BEREWOOD : PHASE 2

Design and Access Statement - Addendum

Rev D - 15 May 2014

This Design and Access Statement addendum is intended to provide supplementary information in relation to the Phase 2, reserved matters application for the Berewood development, Waterlooville.

Typical affordable 3 bed house designed to meet Lifetime Homes

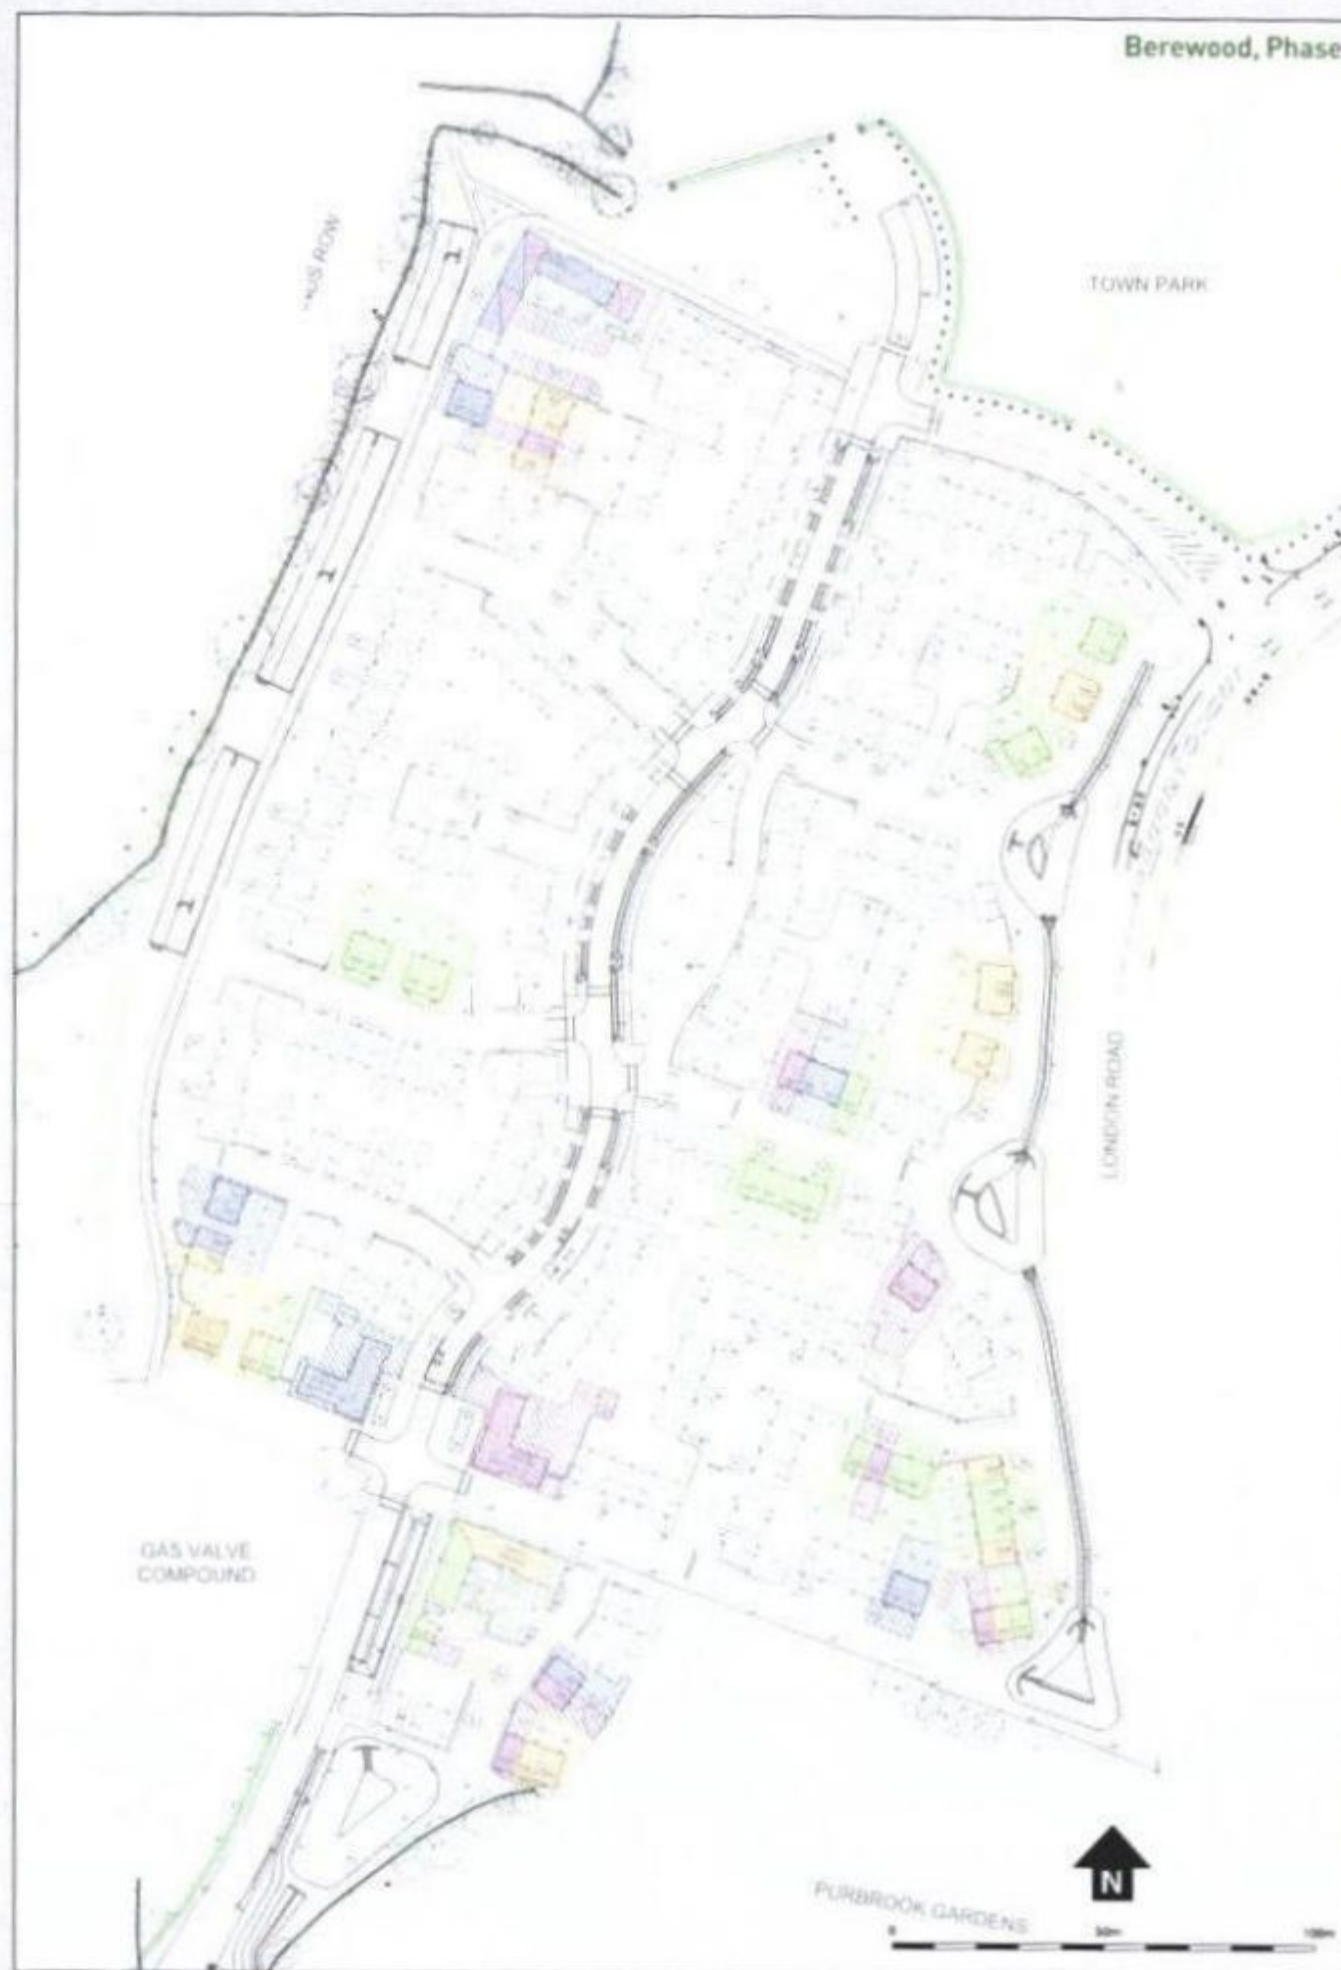
All the affordable homes and flats have been redesigned to be Lifetime Homes compliant. The amendments have resulted in an increase in the size of all properties to accommodate the 16 point requirements of Lifetime Homes. The scheme including private units is now fully Lifetime Homes compliant.

Flat block 'A' front elevation with changes made.

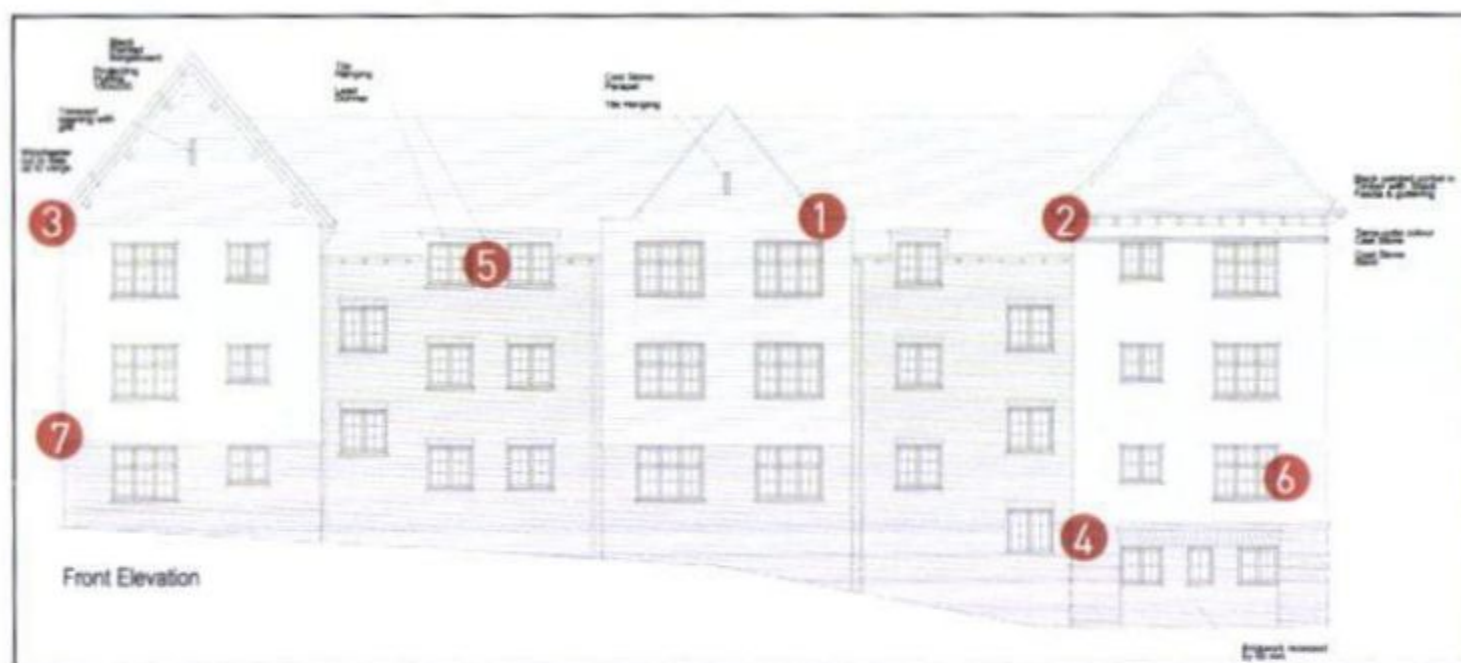
Comments on the elevational appearance of Flat Block A related to the lack of attention to detail in the CAD drawings when contrasted with the handdrawn version. Rather than add extraneous features our approach has been to examine the elevation and enhance the architectural detail of main elements which are;

- The pair of rendered towers at each end of the elevation and
- The central tile hung gable.

Sketches and coloured diagrams show where the original elevation has been amended and the details that are to be enhanced.

Detail 4: Wall and Base (1:5)

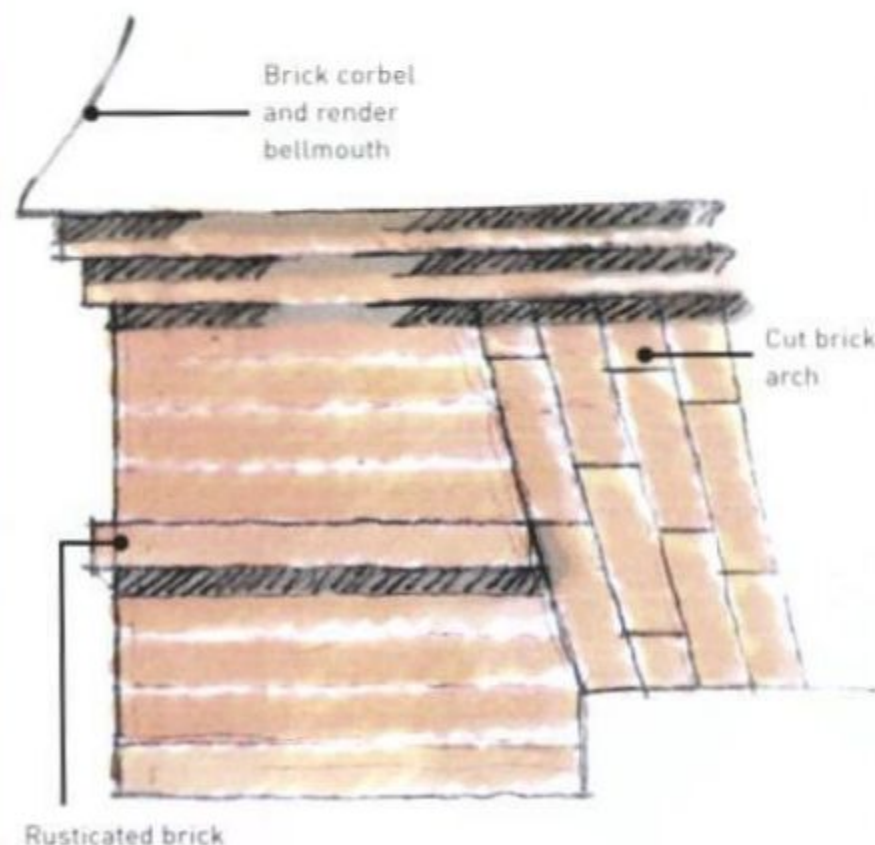
The brick base to the feature tower will be enhanced using a double skin of brick work. This will allow a central recess of 100mm to be created between the brick rusticated piers
